CITY OF SOMERVILLE, MASSACHUSETTS
INSPECTIONAL SERVICES DEPARTMENT
KATJANA BALLANTYNE - MAYOR

Re: Site Address: 16-20 Medford St
Permit(s): B24-000161
Subject: Request for Enforcement
Date: August 8, 2024

Re: 16-20 Medford Street building permit B24-000161, Request for Enforcement

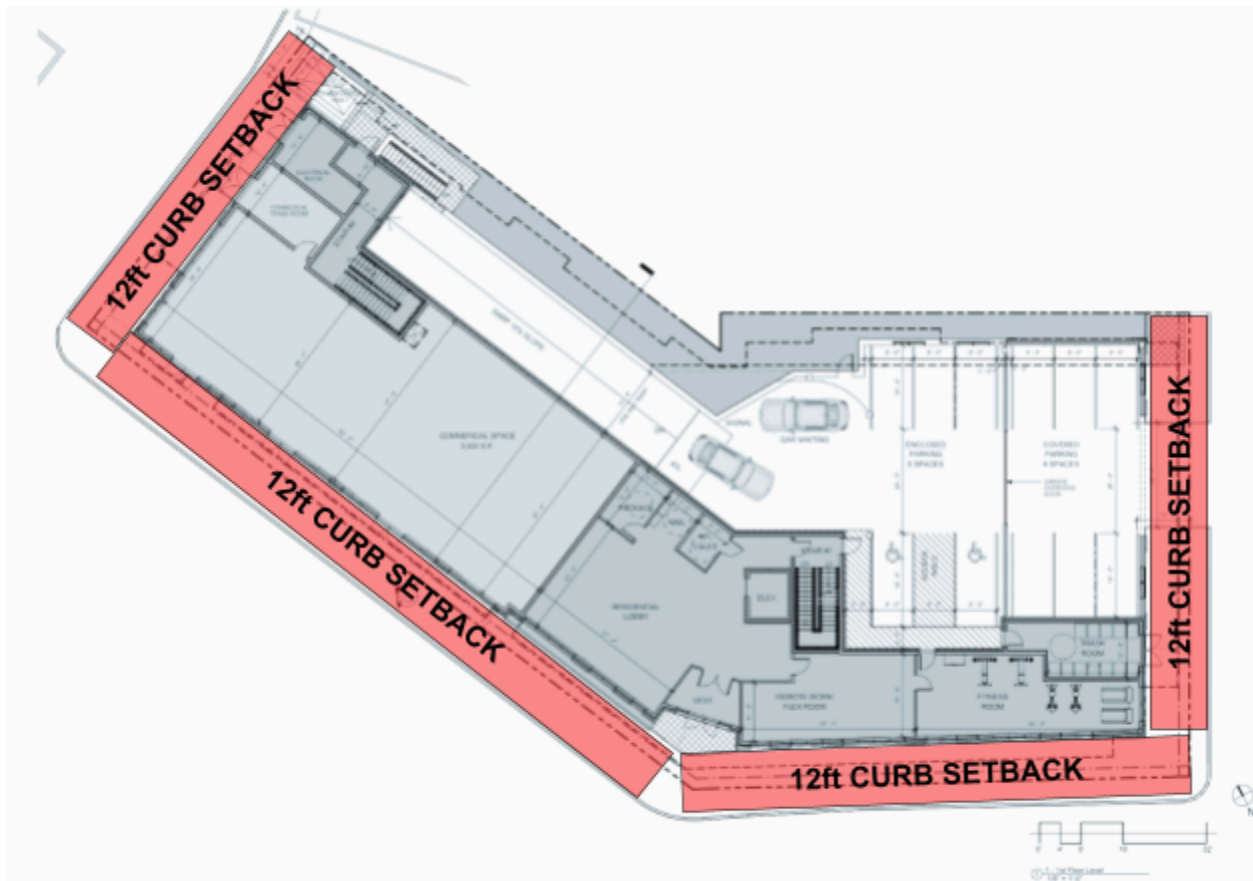
Issue #1. The Development violates Curb Setbacks on all four street frontages.

Please note that no building components (including Bay Windows) can encroach on the Curb Setback, per SZO. The corresponding setbacks for 16-20 Medford Street are depicted below:

Please note that there are a lot of building components (decks, bay windows), especially on the Warren Street and Bedford Street sides, encroaching onto Curb Setback according to permit plans. All these building components should be re-designed to not encroach on the Curb Setback.

Response: The intent of the curb setback is to furnish a space for a sidewalk in the frontage of a building. Curb setbacks are necessarily treated as front setbacks for the purposes of reviewing building encroachment of building components. Per SZO §4.2.10.j.D, bay windows may encroach into a front setback by a maximum of 3 ft in an Mid-Rise 4 (MR4) district. Per SZO §4.2.10.k.B, balconies may encroach into a front setback by a maximum of 6 ft in an MR4 district.

j. Bay Window

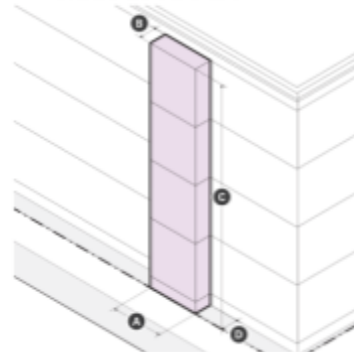
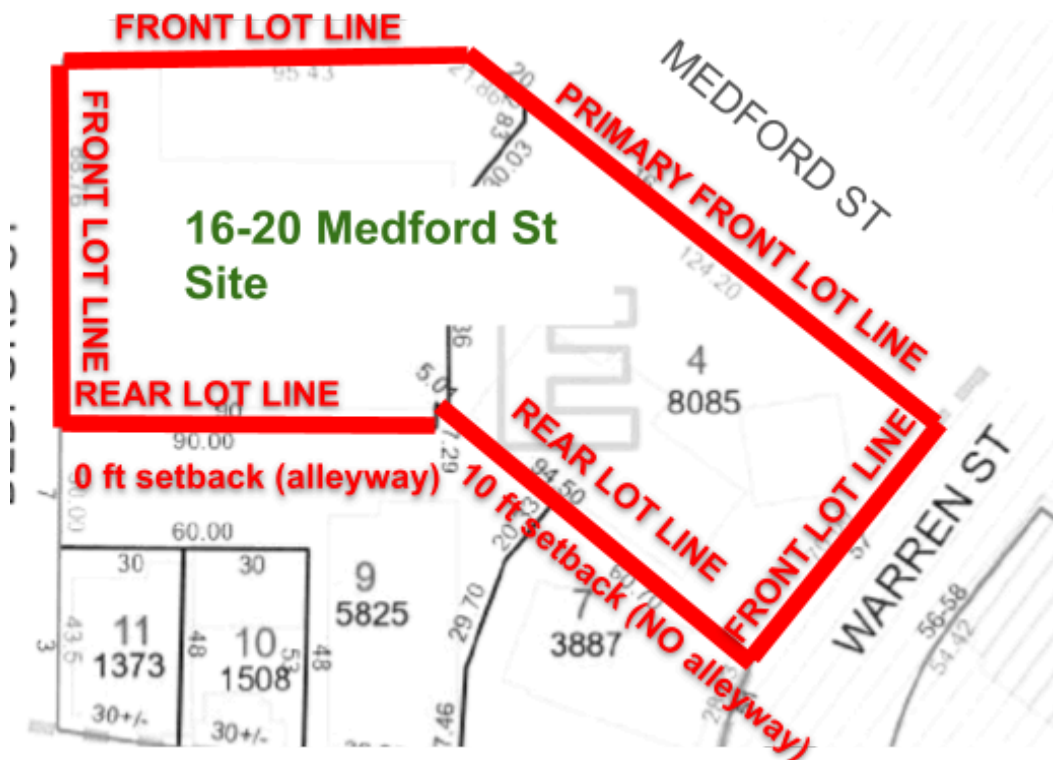
1. The Development violates Curb Setbacks on all four street frontages.

In particular, the Bay Windows are not allowed to encroach on the Curb Setback:

No Curb setback encroachment allowed

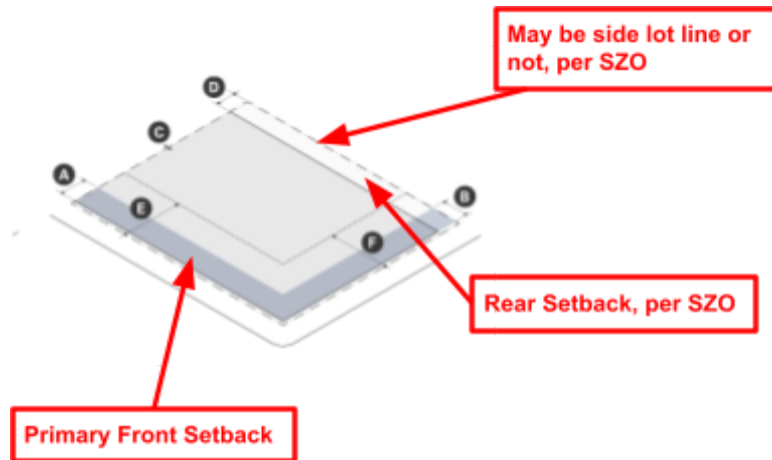
2. The Development violates Rear Setback requirement.

The proper lot line designation of the lot lines of the Property is presented on the following drawing:

The lot line that should have a 10ft setback is the right REAR LOT LINE (without the alley) on the figure above.

Response: The lot lines of the Project abutting 7 Bedford St and 51 Warren St were determined to be side lot lines, not rear lot lines. Per SZO §2.1.1, a rear lot line is any lot line which is parallel to or within forty-five (45) degrees of being parallel to a front lot line, unless that lot line is a side lot line of an abutting lot. Both lot lines abutting 7 Bedford St and 51 Warren St are side lot lines of abutting lots. Rear setbacks would not be applicable to these lots, as rear setbacks are measured from rear lot lines.

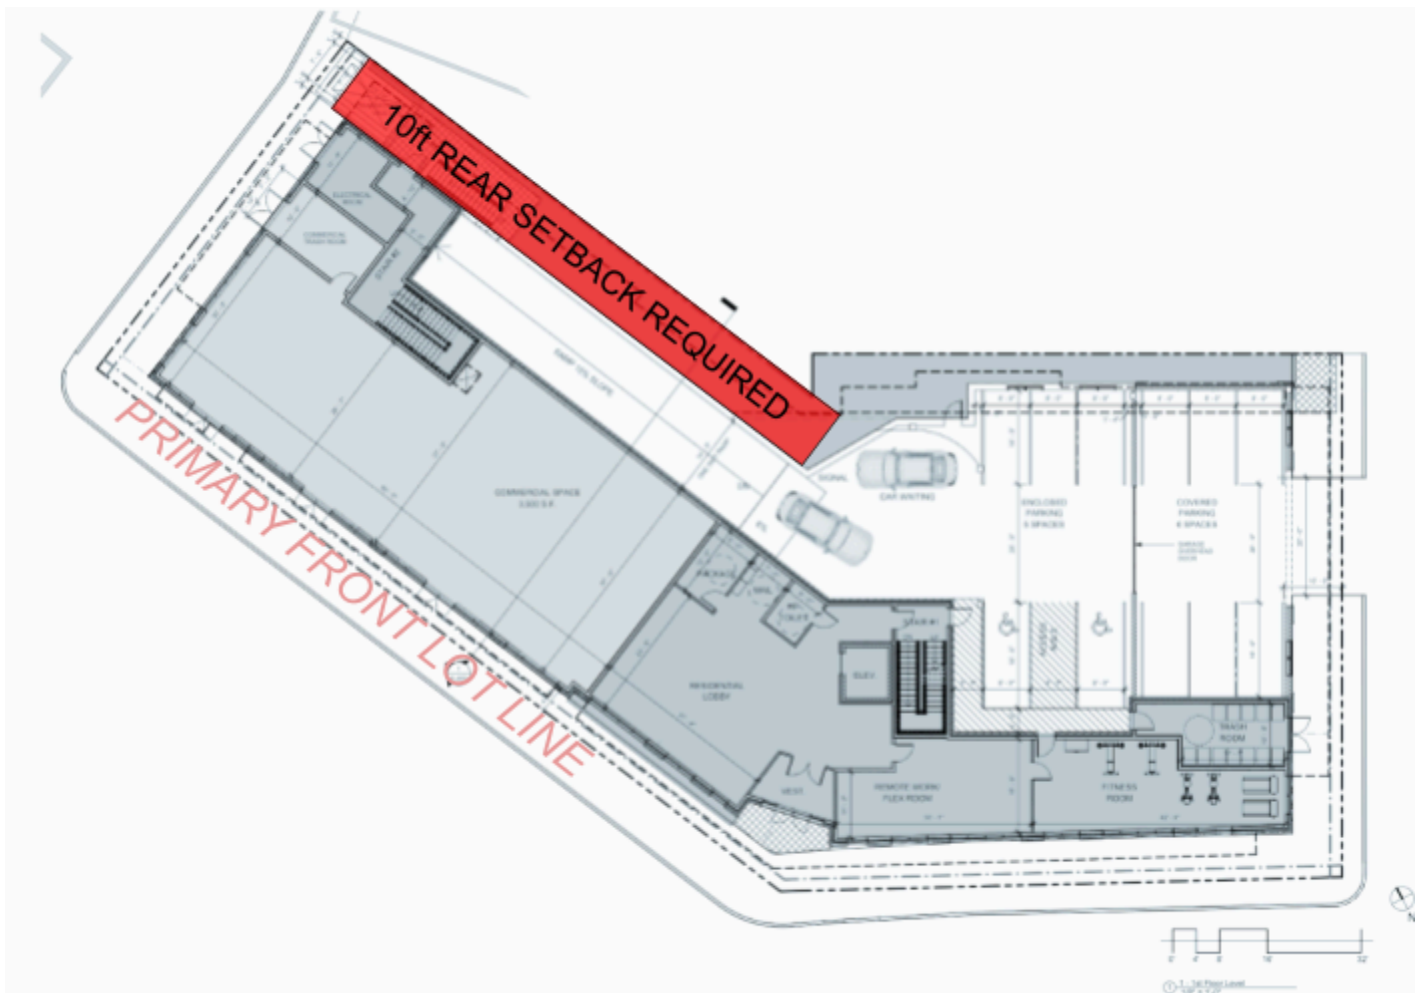
Regardless of the lot line designation, because it is located opposite of the Primary Front Lot Line (Medford St) of 16-20 Bedford Street, a REAR SETBACK is applicable to this lot line, by contextual drawing per SZO 4.2.8. b):

Here, the “Rear setback” (D) is depicted as the opposite of the “Primary front setback” (A). It is reasonable to assume that prescriptive drawing would mandate rear setback to be located along the opposite side of the Primary Front Lot Line. Please note that the line with Rear Setback may or may not be a Rear Lot Line, which, per SZO, depends on the adjacent lot’s arrangement. The

The required setback is depicted in RED on the figure above. As one can see, there are a lot of building components that encroach onto this setback. The Developers should reconfigure the building in order to not encroach onto this setback.
